ADEQUACY OF STATION ELECTRIC DISTRIBUTION SYSTEM
VOLTAGES, CRYSTAL RIVER UNIT 3, DOCKET NO. 50-302,
TAC NO. 12743

INTERIM REPORT

Report No. EGG-EA-5338

Paul C. Shemanski, Division of Licensing

CRYSTAL RIVER
UNIT 3
ONE LINE DIAGRAM
FIGURE 1

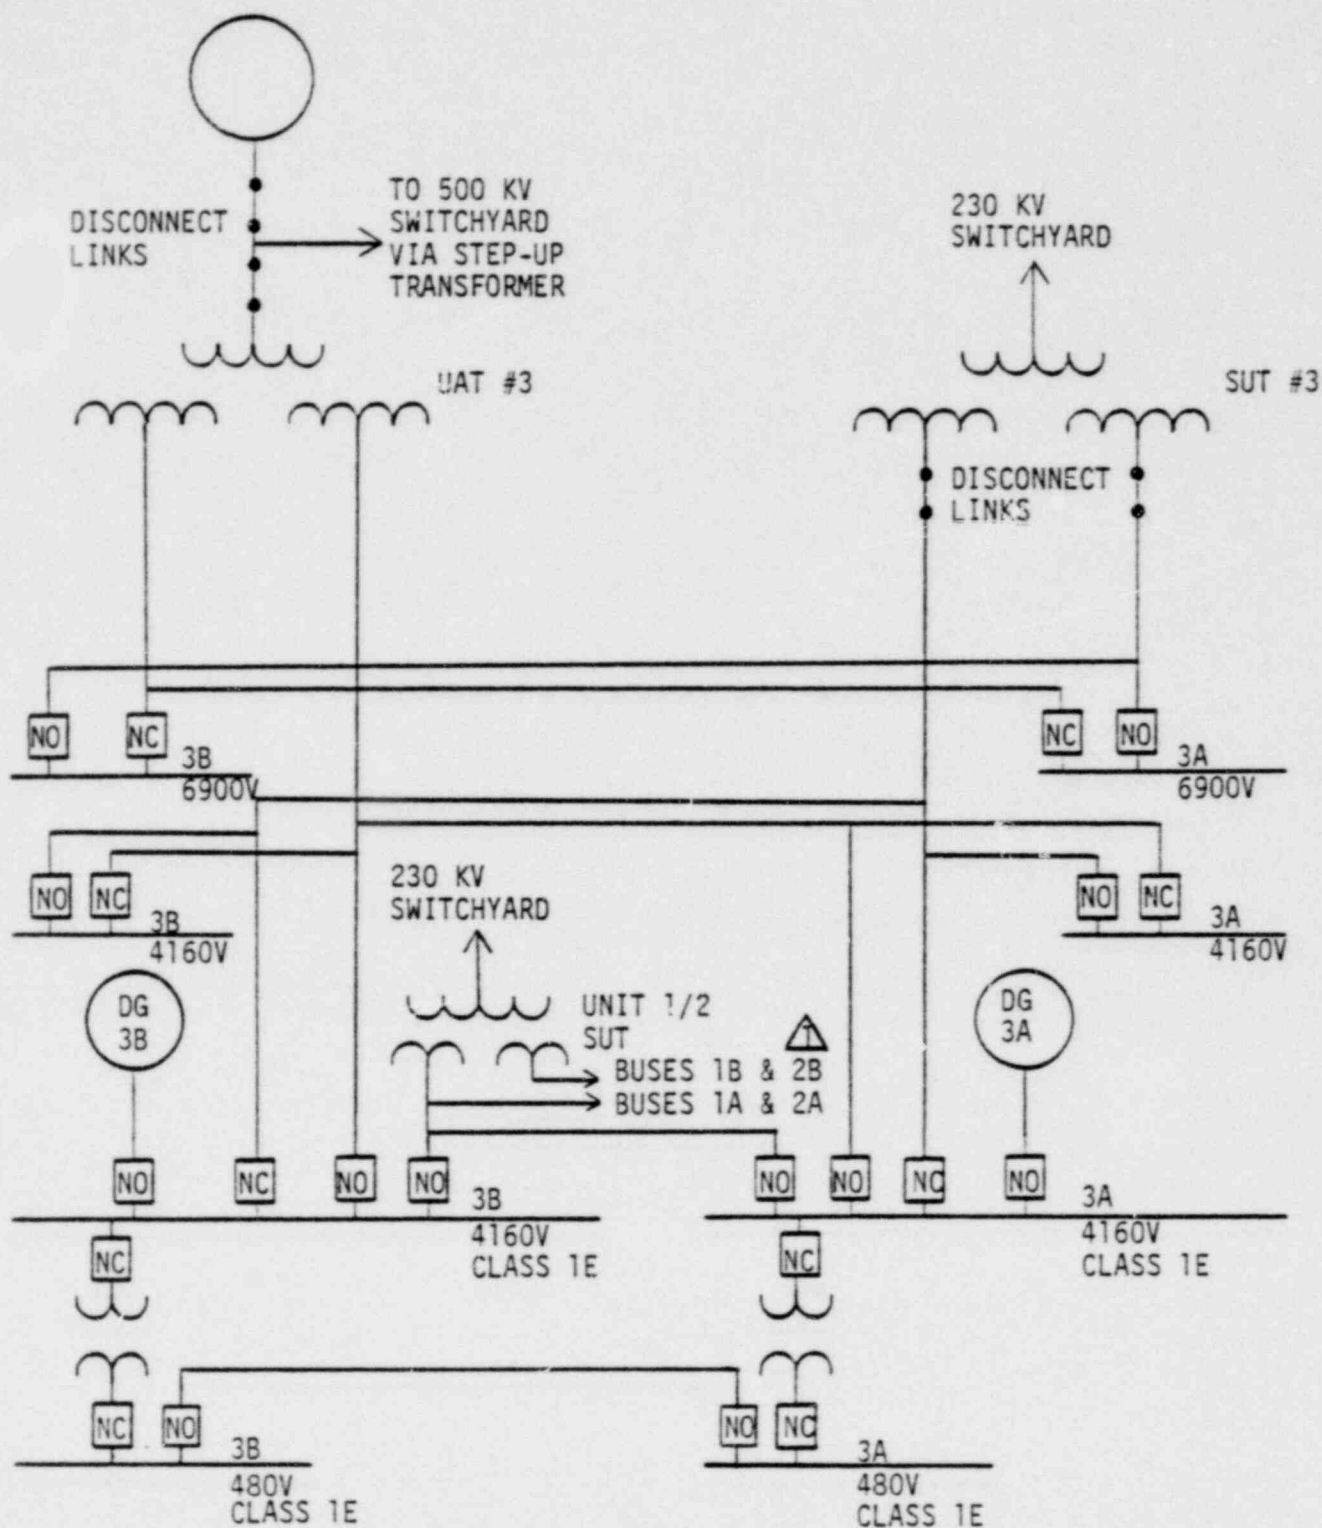
- ⚠ THESE 4160V BUSES ARE IN FOSSIL FUELED UNITS 1 AND 2.
2. UNITS 1 AND 2 OUTPUT CONNECTED TO 230 KV SWITCHYARD.
